NAME & NUMBER OF PROJECT: Boat Dock for 5 Humboldt Lane
SP-2013-0133D

REQUEST: 1) Variance request is as follows: To allow construction of a boat dock and the associated access trail within a Critical Environmental Feature buffer, 25-8-281(C)(1)(a).

MEMORANDUM

SUBJECT: Boat dock for 5 Humboldt Lane, SP-2013-0133D

Boat Dock Application for 5 Humboldt Lane
Attachment 1 - Site Context, Aerial Photo
COA Case No. SP-2013-0133D

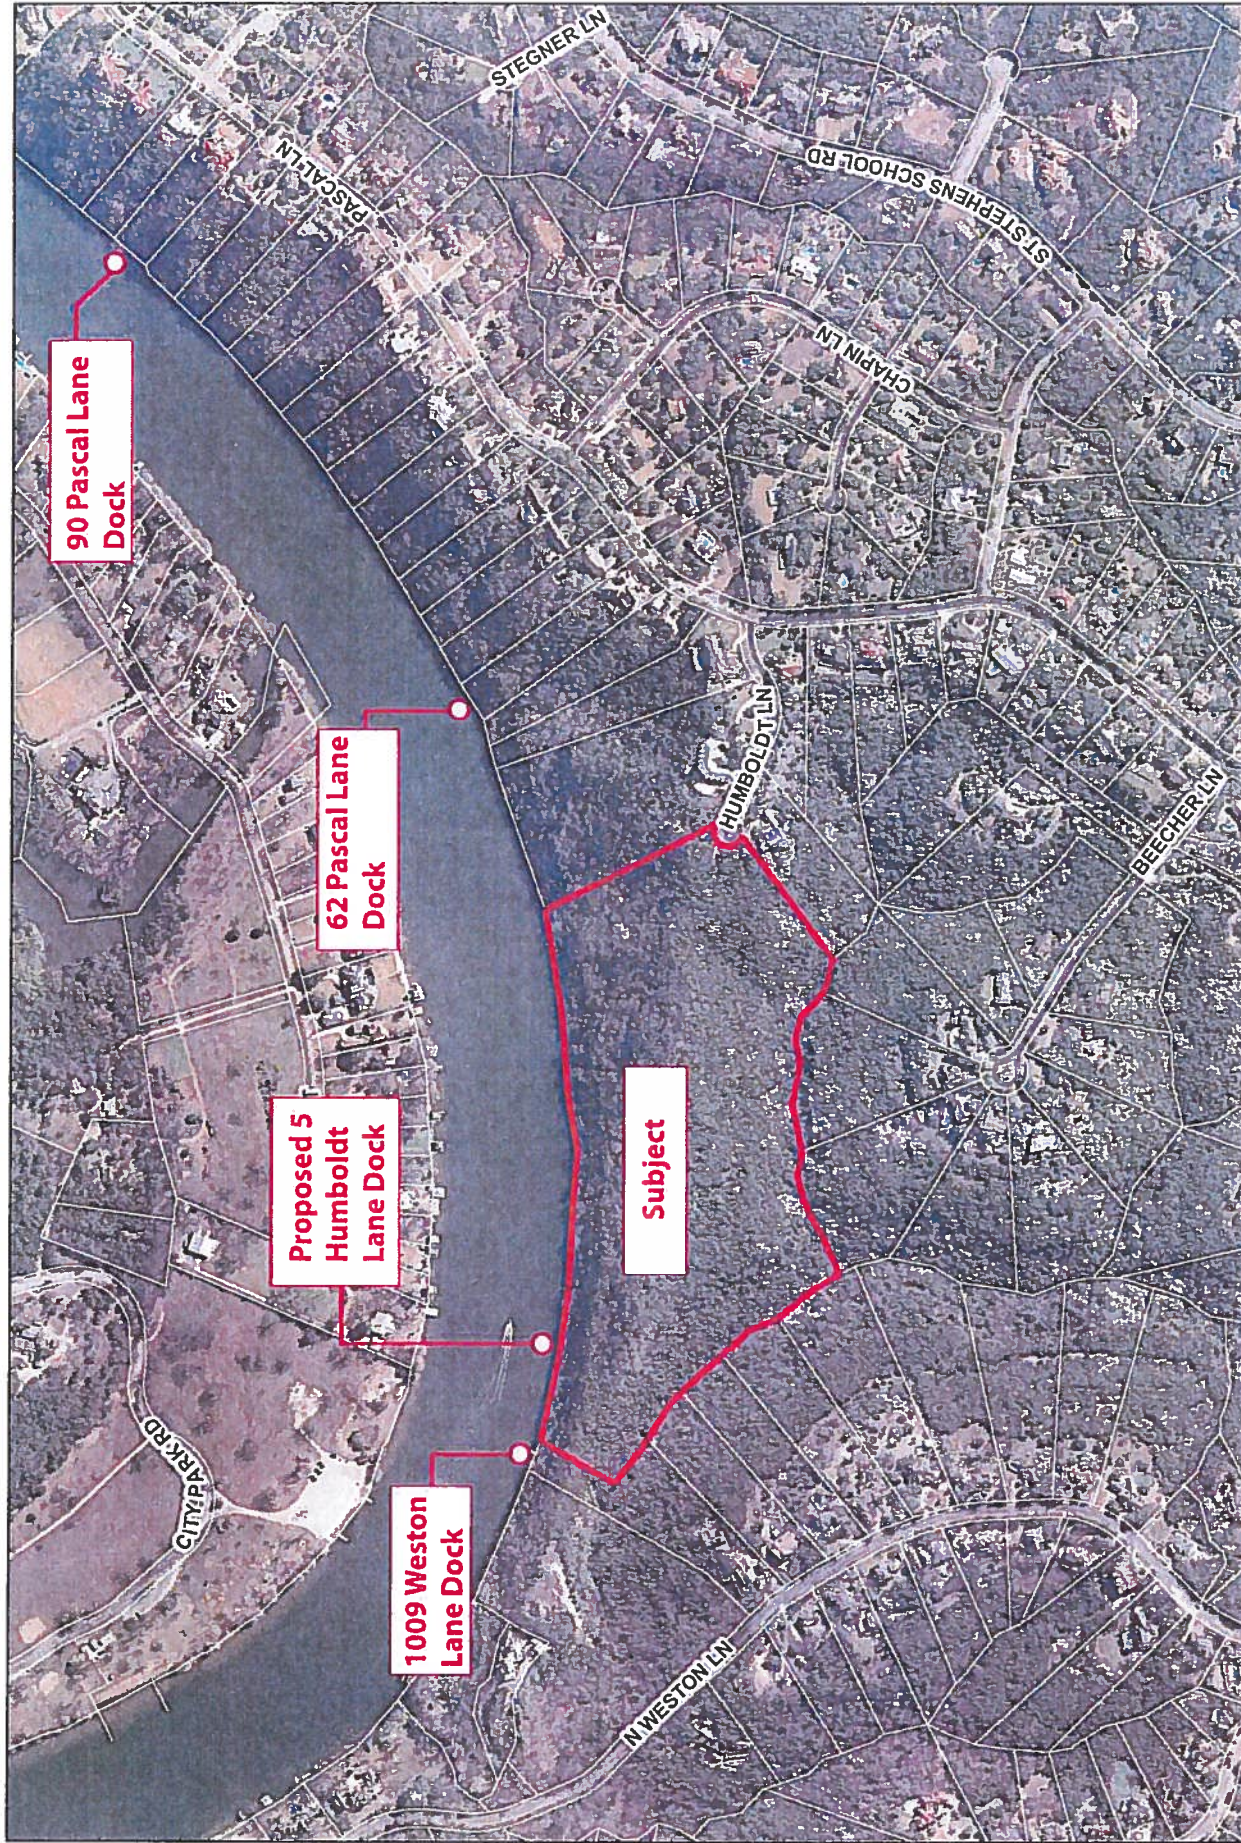
Yes. Strict application of the 150-foot buffer requirement deprives the owner of privileges enjoyed by other lakefront properties. The City has granted approvals to the owners of lakefront lots located upstream and downstream of the subject lot for the construction of docks and means of access to them within the buffer zones of similar rimrock CEF's.

(See Attachment 1, Site Context - Aerial Photo of Lake Austin, and Attachment 2, Tabulation of Approved Boat Docks - with similarly situated property and contemporaneous development).

SITE PLAN AND
CONSTRUCTION DETAILS

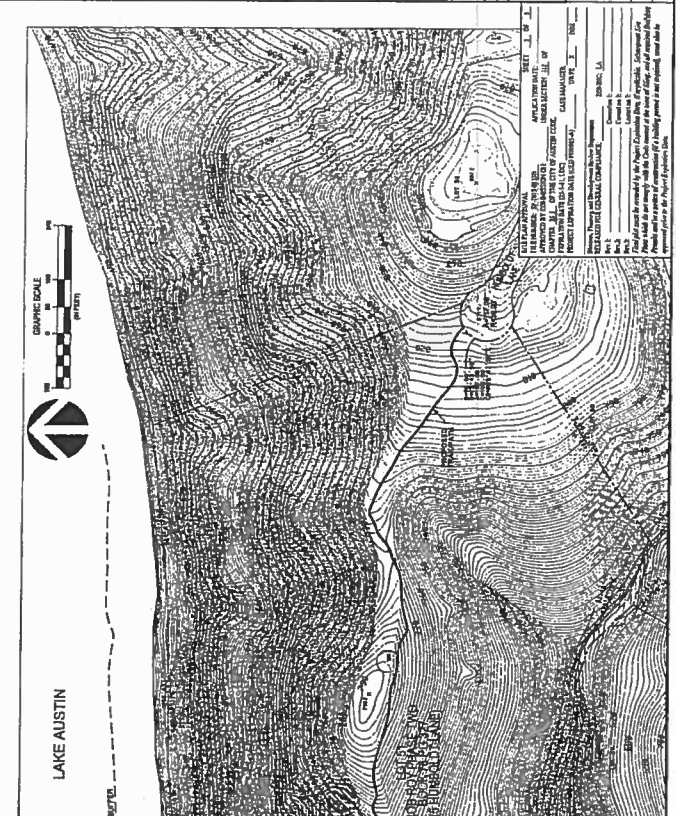
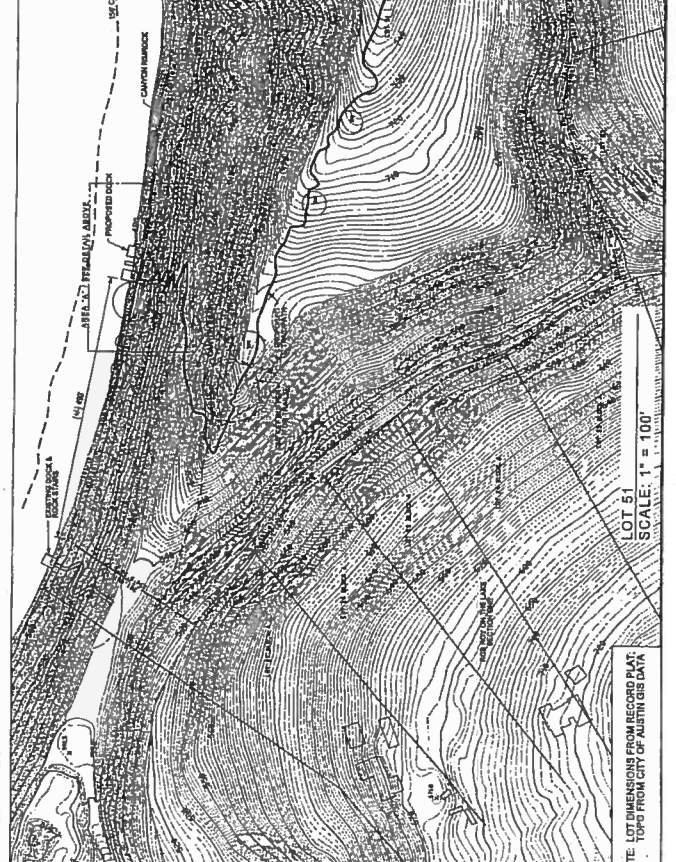
The owner requests a variance to construct a boat dock and its necessary access trail/path within the buffer zone of a canyon rimrock Critical Environmental Feature (CEF). The rimrock CEF extends along the majority of the property's frontage on Lake Austin. The locations of the proposed dock and its access trail/path with respect to the CEF buffer zone are depicted on the site plan. (See Attachment 3)

The proposed alignment of the access trail/path follows a narrow ridgeline to minimize disturbance of areas with steep slopes. Along the lower portion of the path that traverses steep slopes, the applicant has modified the path's alignment to follow an existing animal path as requested by the city staff during a site visit on May 1, 2013. The applicant proposes to construct a mortared rock stair over and along the exposed edge of the canyon rimrock. The construction details for the stair stipulate that no disturbance of the rimrock or its vegetation shall occur except in those areas in contact with the stair. The applicant will utilize on-site weathered limestone to construct the stair in a comparable manner to the stairs built over a similar rimrock formation to access a dock located immediately upstream of the subject lot.

- 1) Applicant must agree that no trams will be constructed to provide shoreline access.
